TRANS/WP.29/GRSP/25
7 July 1999

Working Party on Passive Safety (GRSP)

REPORT OF THE WORKING PARTY ON PASSIVE SAFETY
ON ITS TWENTY-FIFTH SESSION

AMENDMENTS TO THE PROPOSAL FOR A DRAFT REGULATION
CONCERNING REPLACEMENT AIRBAGS AGREED IN PRINCIPLE BY GRSP
(Documents TRANS/WP.29/GRSP/1998/4 and
TRANS/WP.29/GRSP/24, annex 2)

Paragraph 7.2., amend to read:

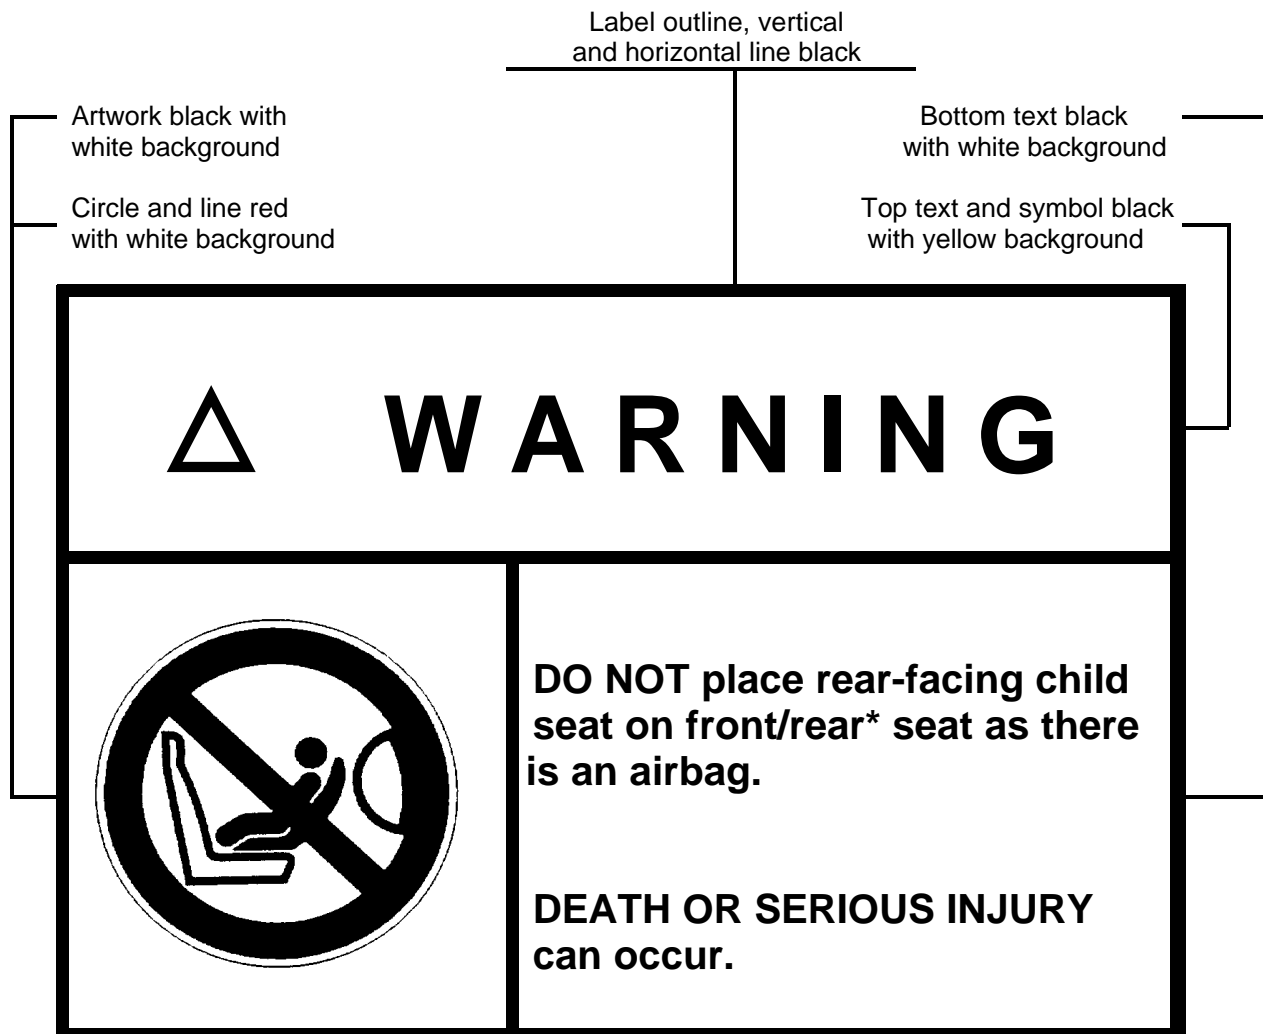
"7.2 The replacement airbag system shall carry labelling and information for the use of child restraint systems according to Regulation No.94.

Airbag devices of category A, B, C or D shall carry the inscription "AIRBAG" located in the interior of the circumference of the airbag steering wheel or on the cover of the airbag module; this inscription shall be durably affixed and easily visible.

In addition, in the case of a frontal protection airbag intended for use in any passenger seating position, the following label shall be permanently attached to the visible surface of the cover of the airbag module (the text information shown is a minimum).

This label shall be provided in the language(s) of the country where the device is sold.

Label minimum size: 60 x 120 mm.

FATIGUE TEST DEVICE

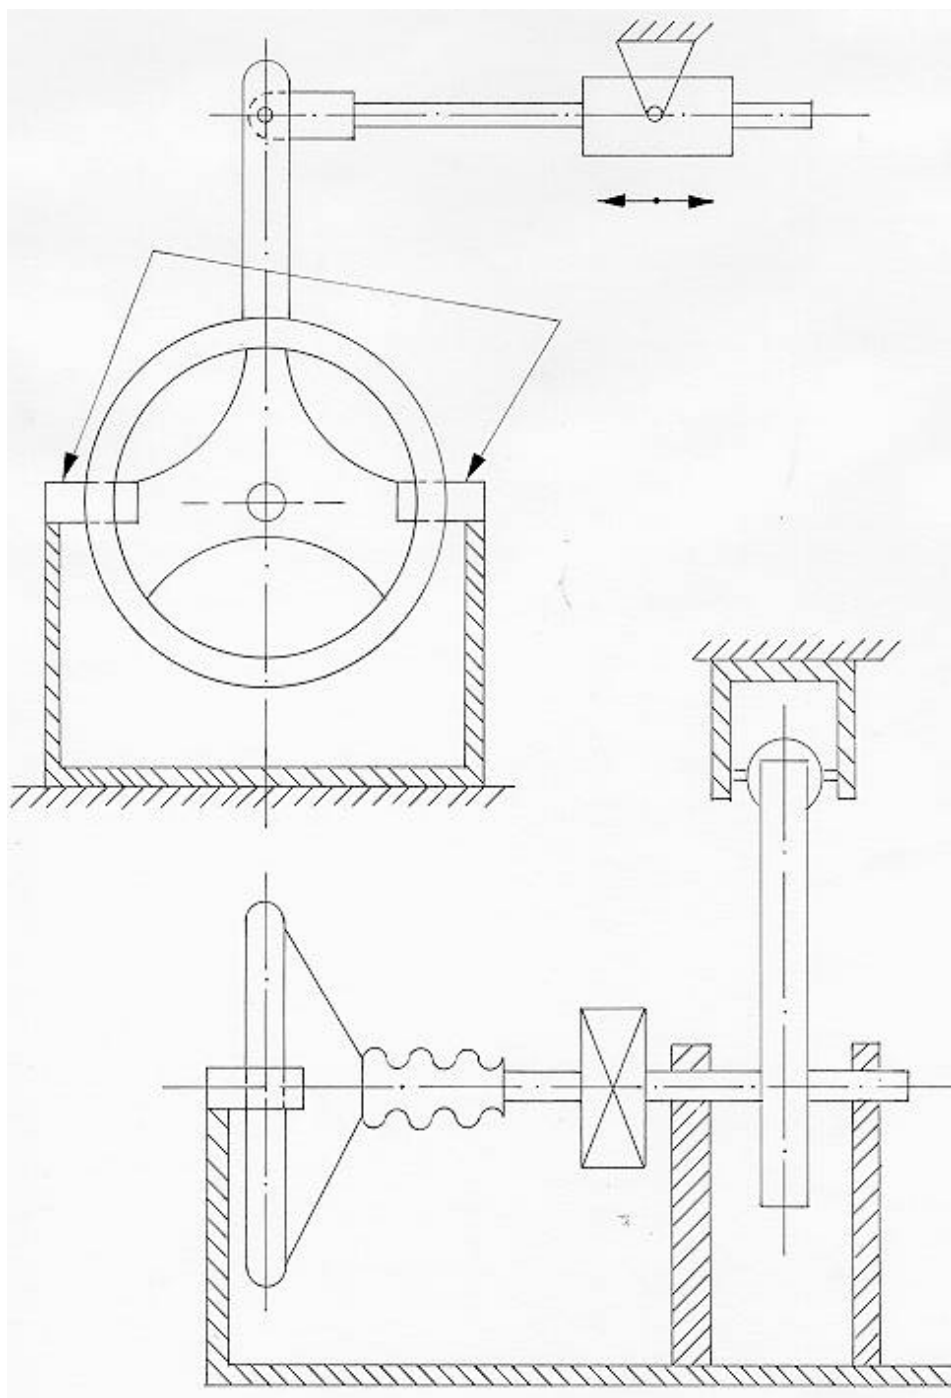
11. The expert from Germany provided a new diagram of the fatigue test device, which is reproduced in annex 2 to this report as a part of the amendments adopted by GRSP.

Annex 9 (former), renumber as annex 7, and amend to read:
"Annex 7
